AGENDA
HAILEY PLANNING & ZONING COMMISSION
Monday, March 9th, 2015
Hailey City Hall
5:30 p.m.

TO: Hailey Planning and Zoning Commission

**DESIGN REVIEW MODIFICATION
 STAFF REPORT**

RE: Design Review Modification submitted by Charles Maguire on behalf of Rob Lonning and Elizabeth Jeffrey's for a new single-family residential dwelling to be located on Lot 11A, Block 47, of the Hailey Townsite, otherwise known as 201 3rd Avenue N.

EAST WALL

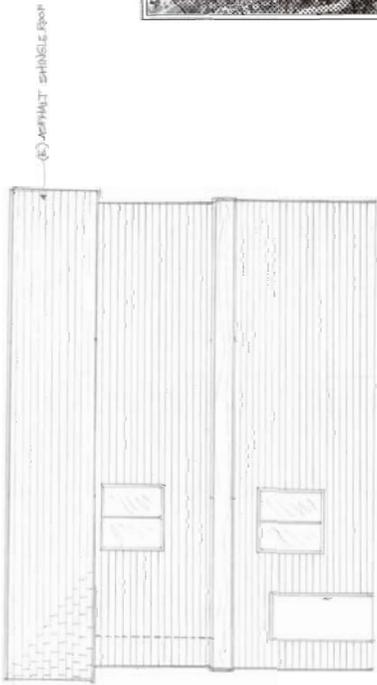
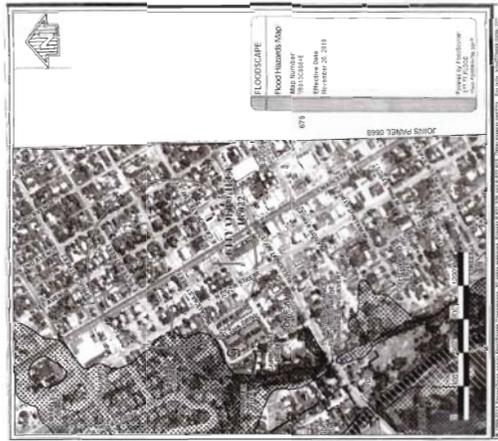
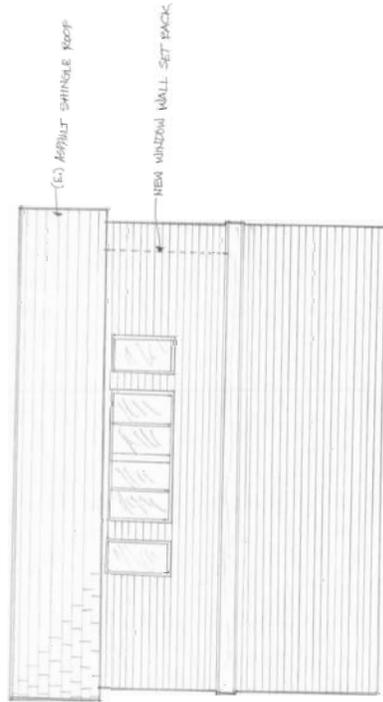
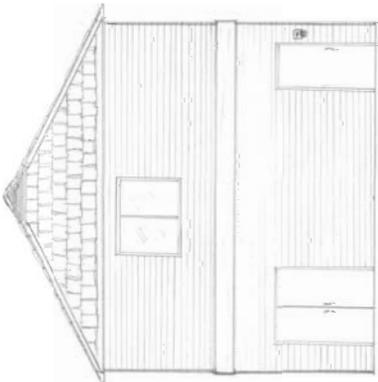
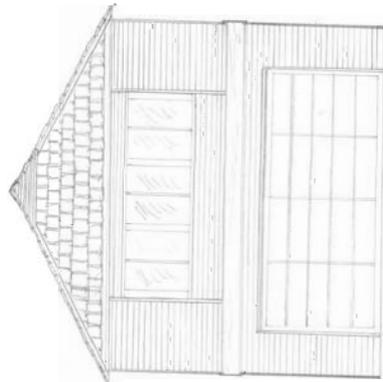
<i>Staff Comments</i>	<ul style="list-style-type: none"> • <i>The existing garage and proposed accessory dwelling unit above is located near the alley side of the lot consistent with the scale and massing of the neighborhood; grid pattern is respected; adequate snow storage exists on the property; the addition will not change the building location.</i>
<input checked="" type="checkbox"/>	<input type="checkbox"/>	<input type="checkbox"/>	6A.9.2	<p>Bulk Requirements (Mass and Scale, Height, Setbacks) Guideline: The perceived mass of larger buildings shall be diminished by the design.</p> <ul style="list-style-type: none"> ➤ The height of taller buildings should be stepped down on the streetside elevation. ➤ Buildings with greater mass should be broken into smaller modules. ➤ Changes in wall planes and building materials should be used to reduce the visual impacts of taller buildings.
			<i>Staff Comments</i>	<i>The proposed addition is within the height limit. The building scale is appropriate for the neighborhood. Visual impact is addressed in the design.</i>

<i>Staff Comments</i>	<i>No changes are proposed to building orientation, which respects the existing grid pattern. The addition aligns the front wall plane.</i>
<input checked="" type="checkbox"/>	<input type="checkbox"/>	<input type="checkbox"/>	6A.9(C)3c	c. Building Form
				Guideline: The use of building forms traditionally found in Old Hailey is encouraged. Forms that help to reduce the perceived scale of buildings shall be incorporated into the design.
			<i>Staff Comments</i>	<i>Traditional building forms are used.</i>
<input checked="" type="checkbox"/>	<input type="checkbox"/>	<input type="checkbox"/>	6A.9(C)3d	d. Roof Form
				Guideline: Roof forms shall define the entry to the building, breaking up the perceived mass of larger buildings, and to diminish garages where applicable.
			<i>Staff Comments</i>	<i>The garage, and the addition to the garage appear subordinate to the primary building. The roof form is a typical gable roof.</i>

<input checked="" type="checkbox"/>	<input type="checkbox"/>	<input type="checkbox"/>	6A.9(C)3f	f. Windows
				Guideline: Windows facing streets are encouraged to be of a traditional size, scale and proportion.
			<i>Staff Comments</i>	<i>Windows proposed on the second floor are of a traditional size and scale.</i>
<input checked="" type="checkbox"/>	<input type="checkbox"/>	<input type="checkbox"/>	6A.9(C)3f	Guideline: Windows on side lot lines adjacent to other buildings should be carefully planned to respect the privacy of neighbors.
			<i>Staff Comments</i>	<i>Windows look out on to the street, alley and rear yard of the subject property and respect neighborhood privacy.</i>
<input type="checkbox"/>	<input type="checkbox"/>	<input checked="" type="checkbox"/>	6A.9(C)3g	g. Decks and Balconies
				Guideline: Decks and balconies shall be in scale with the building and the neighborhood.
			<i>Staff Comments</i>	<i>N/A</i>

4 NORTH ELEVATION

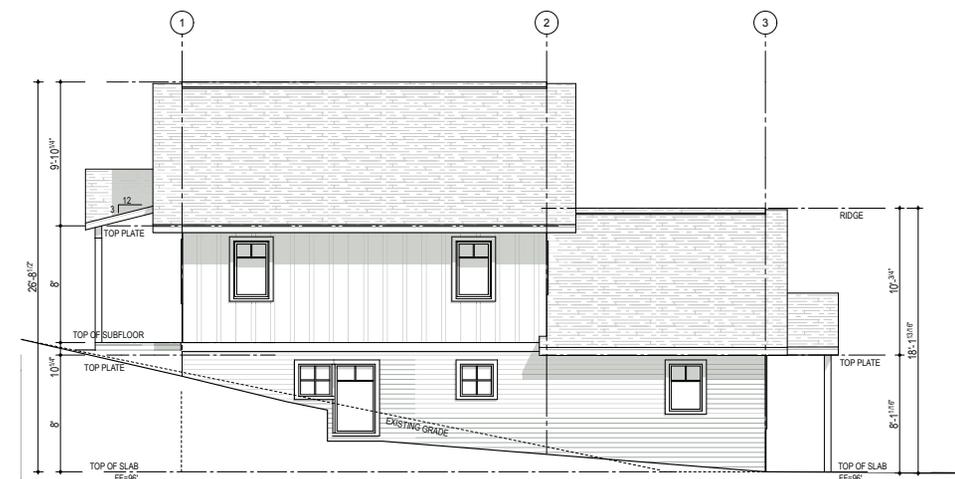
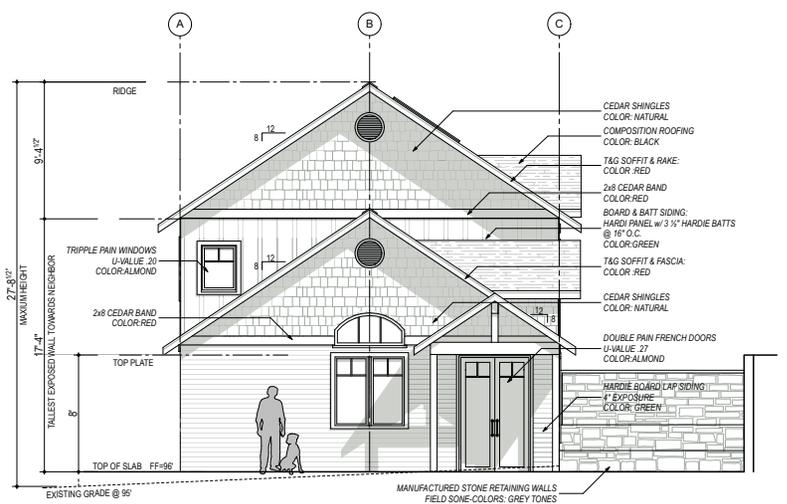
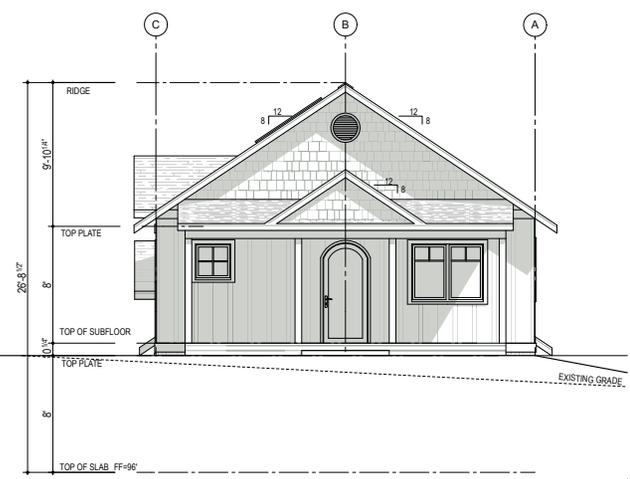
- Revised 2 story section with a gable and a 1 story section of the house as a gable as well stepped down, but with a matching slope to 2nd story. The front entry is now onto 3rd Avenue with a classic old Hailey covered front porch.

- The approved house was 44 x 26 in footprint (44' running east to west). The Revised has a footprint 40x26 (40' running east to west). This has shortened the length of the house by 4' and significantly improves the visual impacts for the neighbors to the North.

- Approved house used the color red as the bulk of the house and mixed Corten and Redwood to break up the color and material to lessen the scale. The revised house uses the same materials as the approved minus the Corten metal and Red wood spaced siding. The Corten metal siding is being replaced with Cedar shingles and the bulk of the house is now green as shown in the color sample.

<p style="text-align: center;"><i>surrounding structures and with the surrounding neighborhood.</i></p> <ul style="list-style-type: none"> • <i>Design effort was made to lower the mass by adding various roof forms and add to the human scale.</i> • <i>Siding was changed in elevation changes to avoid blank walls.</i>

<i>Staff Comments</i>	<ul style="list-style-type: none"> • Windows are more narrow than they are wide, which is consistent with traditional Old Hailey windows.
<input checked="" type="checkbox"/>	<input type="checkbox"/>	<input type="checkbox"/>	6A.9.C.3.f	Windows: Windows on side lot lines adjacent to other buildings should be carefully planned to respect the privacy of neighbors.
			<i>Staff Comments</i>	<ul style="list-style-type: none"> • Windows on adjoining property lines have been minimized and oriented away from the neighboring dwelling.
<input checked="" type="checkbox"/>	<input type="checkbox"/>	<input type="checkbox"/>	6A.9.C.3.g	Decks and Balconies: Decks and balconies shall be in scale with the building and the neighborhood.
			<i>Staff Comments</i>	<ul style="list-style-type: none"> • No decks or balconies are proposed.
<input type="checkbox"/>	<input type="checkbox"/>	<input checked="" type="checkbox"/>	6A.9.C.3.g	Decks and Balconies: Decks and balconies should be designed with the privacy of neighbors in mind when possible.

A1.1 11x17 SITE PLAN

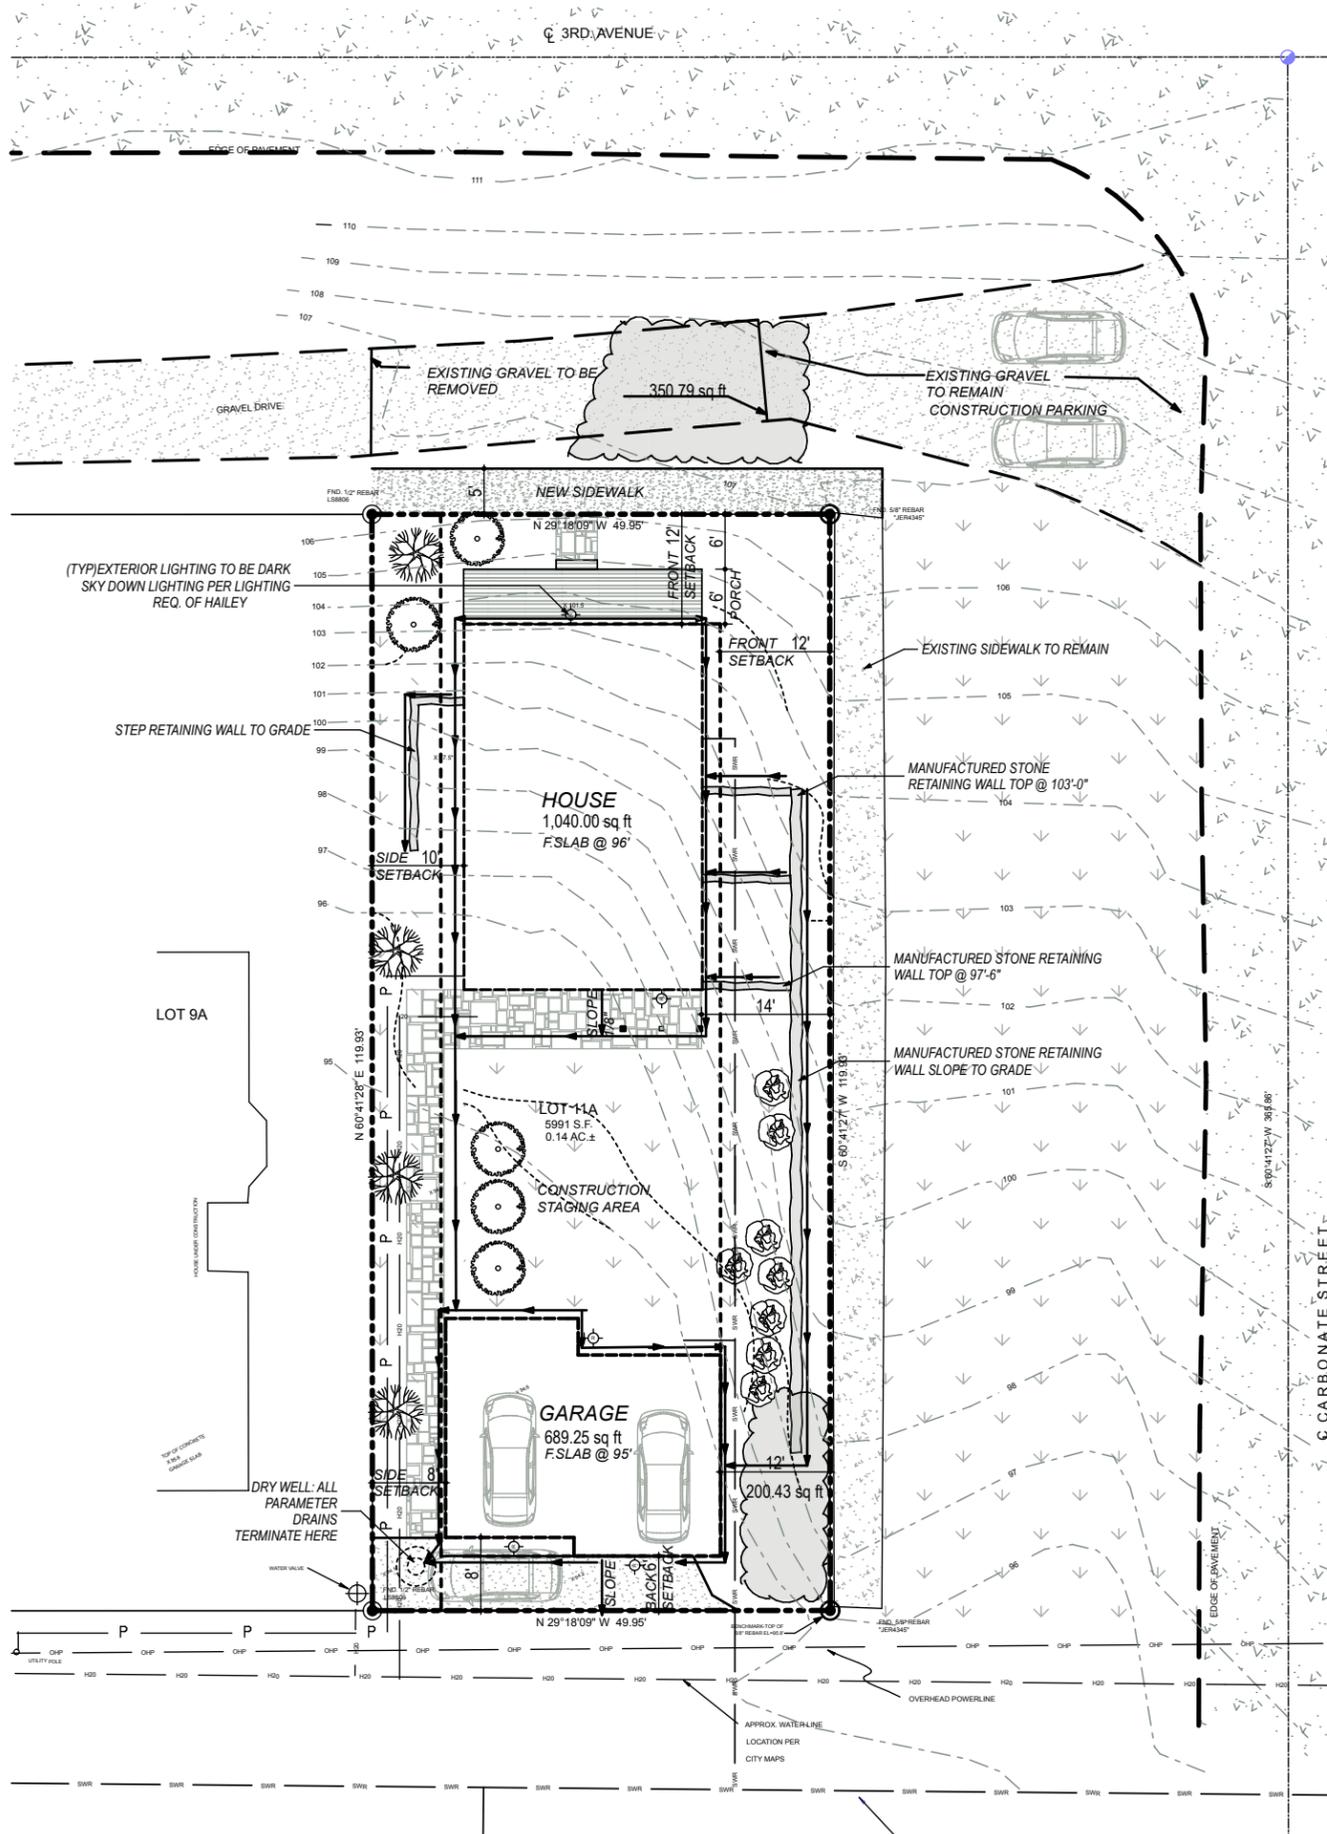
<i>Staff Comments</i>	<ul style="list-style-type: none"> The proposed site plan and development is consistent with the required site planning guidelines. Where possible, access is provided from the alley to the garage All utilities will be located underground as shown on the site plan for both lots. All utilities for both the dwelling are accessed from the alley.
<input checked="" type="checkbox"/>	<input type="checkbox"/>	<input type="checkbox"/>	6A.9.C.1	The use of energy-conserving designs that are compatible with the character of Old Hailey are encouraged. The visual impacts of passive and active solar designs should be balanced with other visual concerns outlined in these Design Guidelines.
			<i>Staff Comments</i>	<ul style="list-style-type: none"> Majority of glazing is on the south side Windows are triple paned, e-value of .20 (Pella) House is bermed, which will significantly conserve heat Solar water collection hot water will be utilized. ???

<i>Staff Comments</i>	<ul style="list-style-type: none"> The alley is currently graveled and no improvements are planned. Noxious weeds will be removed before construction commences.
<input checked="" type="checkbox"/>	<input type="checkbox"/>	<input type="checkbox"/>	6A.9.C.5	Guideline: Landscaping and other design elements adjacent to alleys should be kept simple, and respect the functional nature of the area and the pedestrian activity that occurs.
			<i>Staff Comments</i>	Grade kept as is on alley side and landscaping was kept simple.

<input checked="" type="checkbox"/>	<input type="checkbox"/>	<input type="checkbox"/>	6A.9.C.8	Guideline: Noxious weeds shall be controlled according to State Law.
			<i>Staff Comments</i>	<i>Noxious weeds are present on the site. Developer plans to scrap the two lots bare before beginning construction.</i>
